Service Bulletin

Bulletin No.: P11220

Subject: Front Edge of Door Contacting Rear Edge of Fender While Opening Door

Models: 2014 Chevrolet Corvette
Condition/Concern

3804281

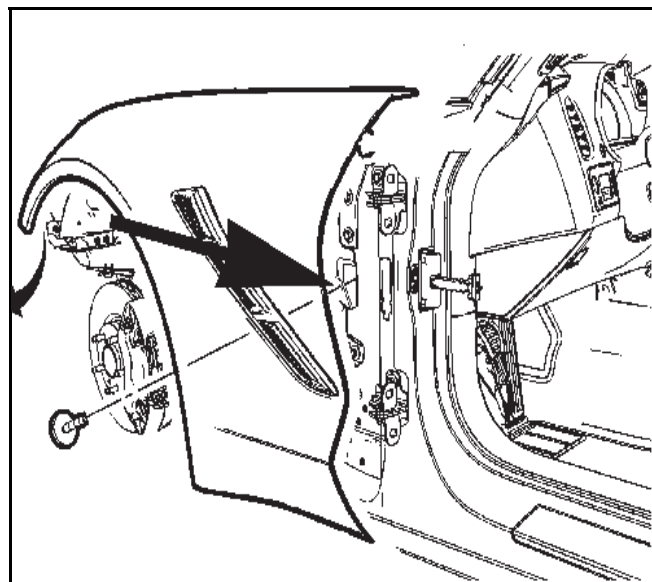
Some customers may comment that the front edge of the front door is contacting the rear edge of the front fender when opening the door. This condition may be present on both the left and right front doors.

3804301

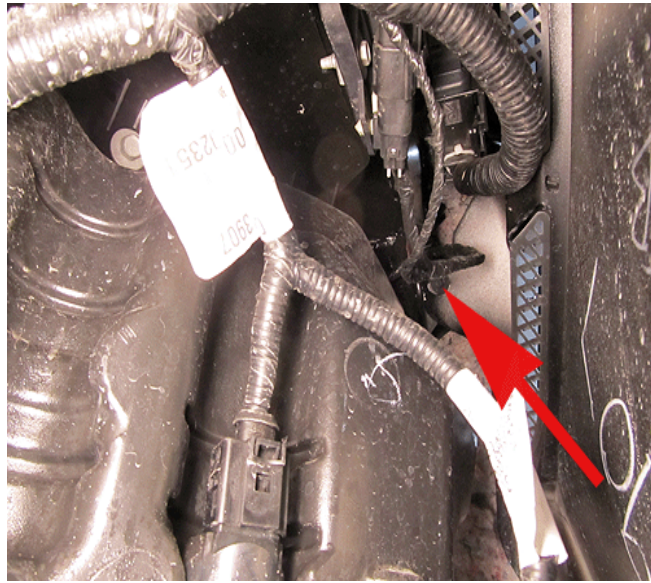
Tip: Remove the rear lower wheelhouse liner fasteners before lifting the vehicle. The hoist pad may block access to one of the bolts.

3804309

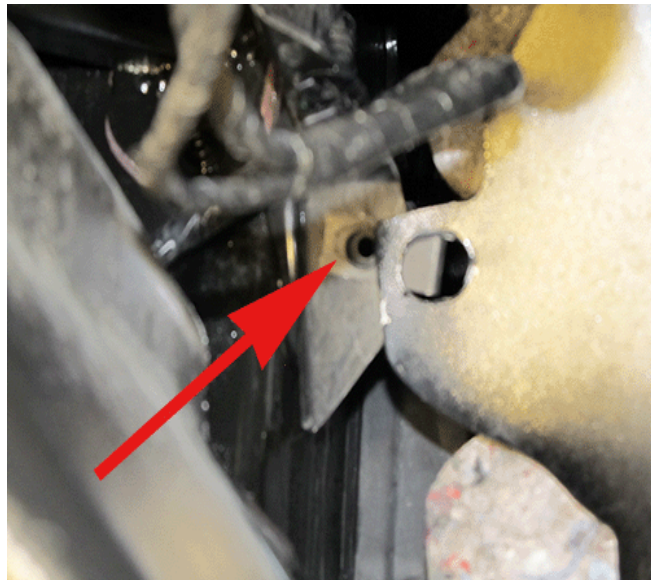
3. Reaching through the wheel opening, remove the center mounting bolt. Discard the bolt.
